Proposed Revisions to a Standard Plans Index

Index Number: 521-010

Index Title: Opaque Visual Barrier

Sheet 1: Section Views - Added barrier delineator placement details and callout; Note 9: Added explanation for how to locate barrier delineators with split barrier sections.

ELEVATION VIEW - OPAQUE VISUAL BARRIER

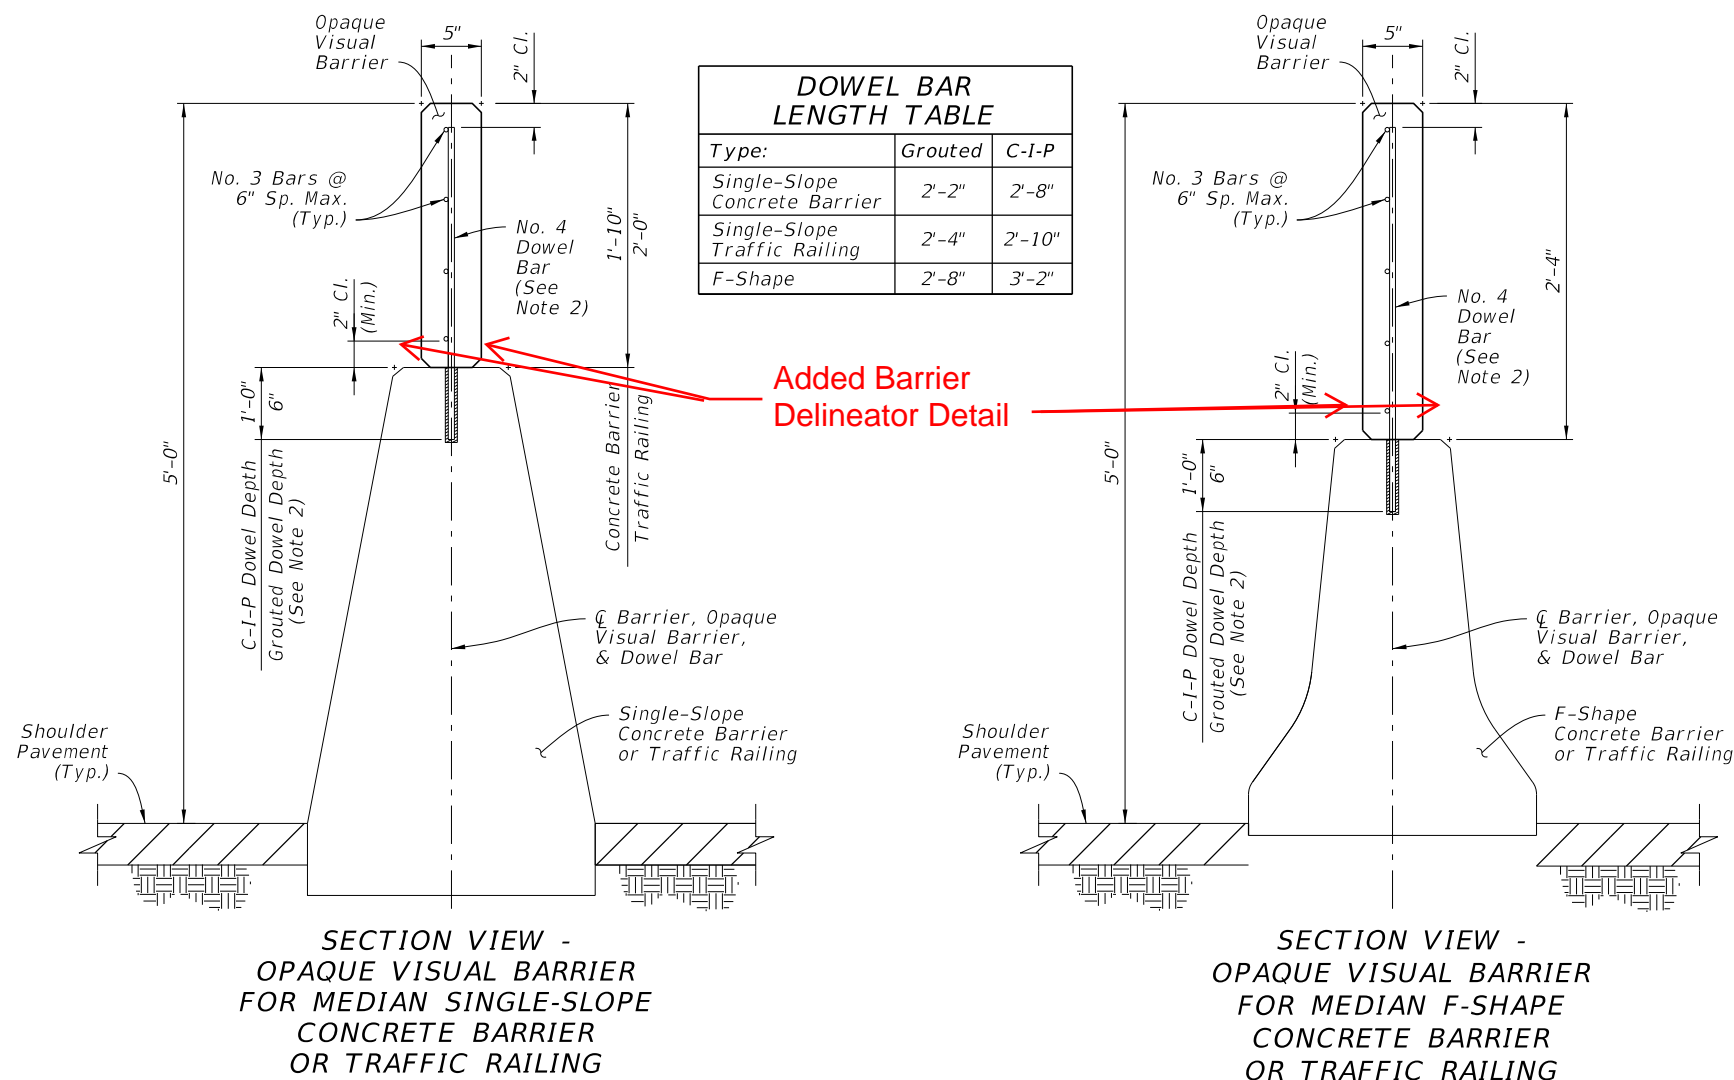
Added Barrier Delineator placement instruction

Added Barrier Delineator Detail

SECTION VIEW - OPAQUE VISUAL BARRIER FOR MEDIAN SINGLE-SLOPE CONCRETE BARRIER OR TRAFFIC RAILING

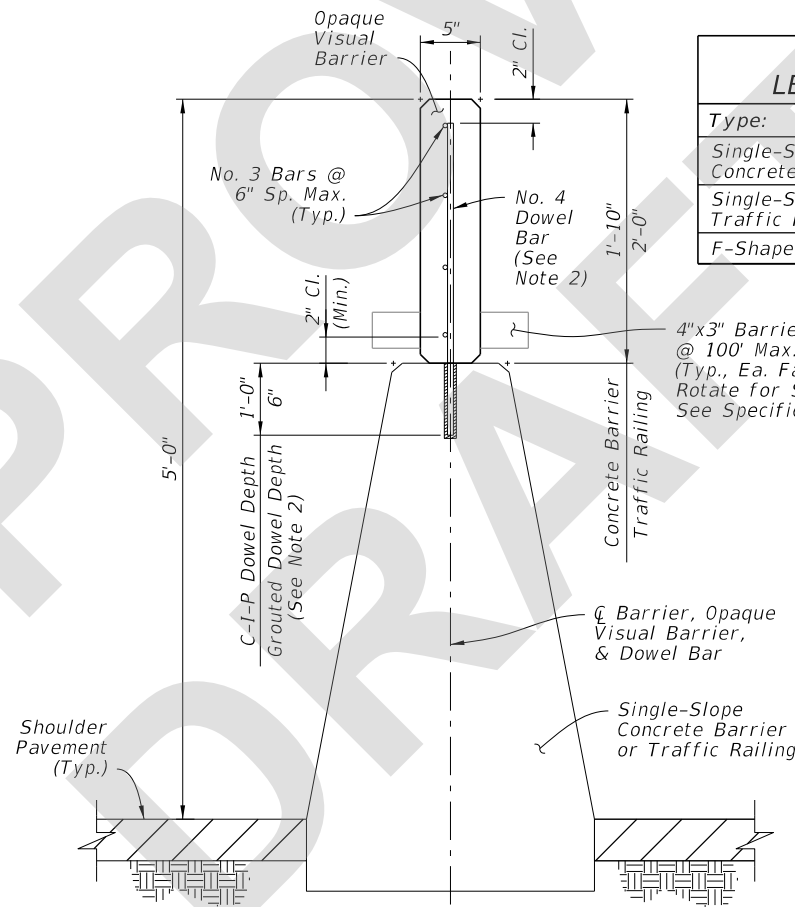
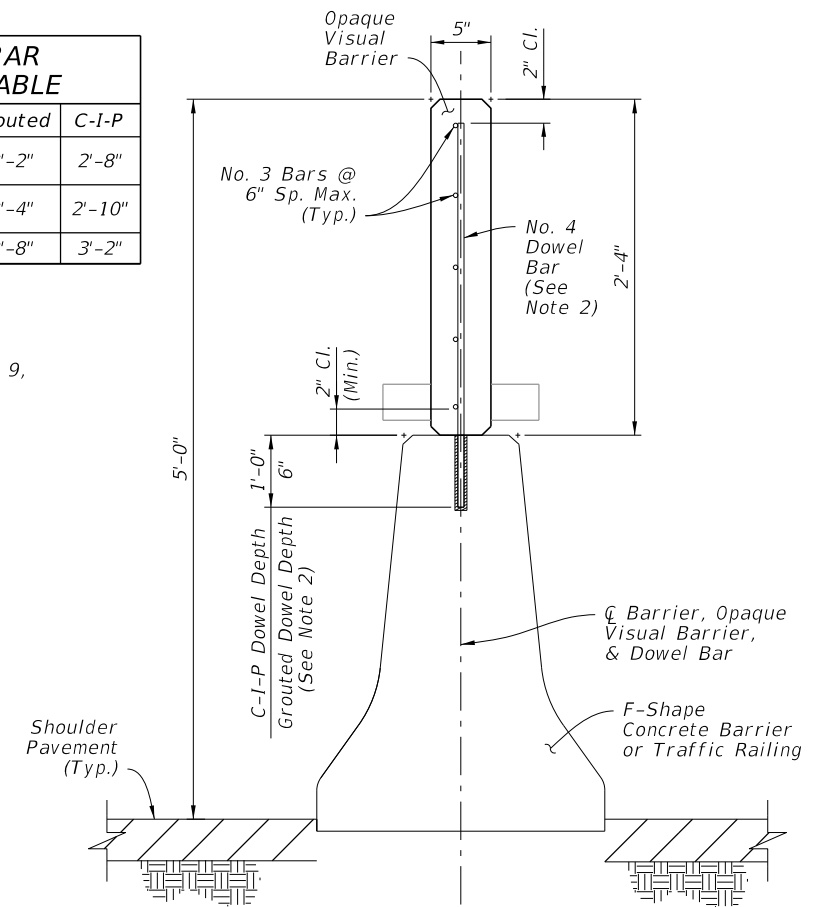
Added detail to clarify placement location of barrier delineators when an Opaque Visual Barrier blocks the standard placement location on top of the barrier.

9. SPLIT CONCRETE BARRIER SECTIONS: For split Concrete Barrier sections that run separately (for vertical structures, bridges, etc.), OVB is only required on top of one of the Concrete Barrier sections. Place OVB on top of the Concrete Barrier section with the highest elevation. For these segments, mount barrier delineators on only the OVB face nearest the roadway (barrier mount other side). Longitudinally overlapping OVB runs are permitted where called for in the Plans, as designated with overlapping Begin and End Station OVB callouts.
